## Service Bulletin

No. : MZ03-005

**Model:** SA8260

**Subject:** Improvement to playability of CD and Super Audio CD

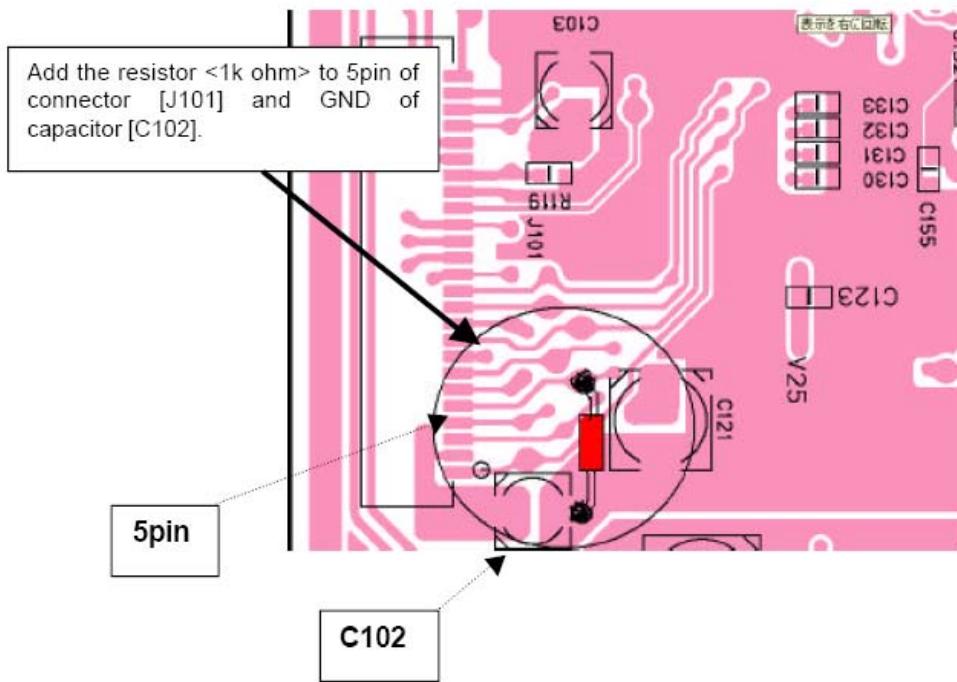
**Symptom:** Will not read TOC, will not start playback, the sound skips with some CD's and Super Audio CD's.

If the LOT number is from 01 to 18 (only). Replace the servo MPU (Micro Processor Unit) [Q125] with the latest one <Drv Ver. 01.34> (Part No. HU01AKY12F) on the [PV16] PCB.

1. Press and hold the [OPEN/CLOSE] and [SKIP/FF] buttons, then connect the power plug.
2. Press the [SKIP/FF] button twice, then the version will show "Drv Ver XX.XX" on the display.2) [01 to 18 Lot only] Add the resistor <1k ohm> (Part No. GD05102160) on the [PV16] PCB as follows;

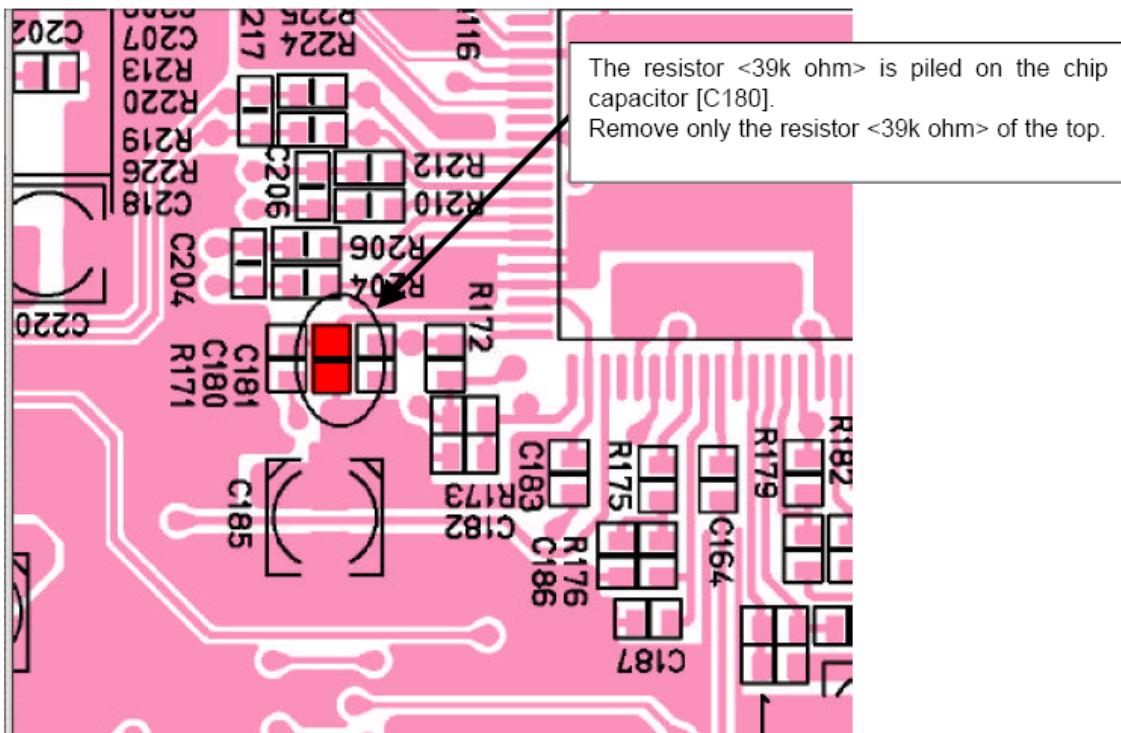
If the Lot # is 19 to 20 only (The LOT number is "##" of serial number "MZxxxxxx##xxxx".) do the following: Replace the servo MPU (Micro Processor Unit) [Q125] with the latest one <Drv Ver. 01.34> (Part No. HU01AKY12F) on the [PV16] PCB.

1. Press and hold the [OPEN/CLOSE] and [SKIP/FF] buttons, then connect the power plug.
2. Press the [SKIP/FF] button twice, then the version will show "Drv Ver XX.XX" on the display.2) [19 to 20 Lot only] Remove the resistor <39k ohm> on the [PV16] PCB as follows;
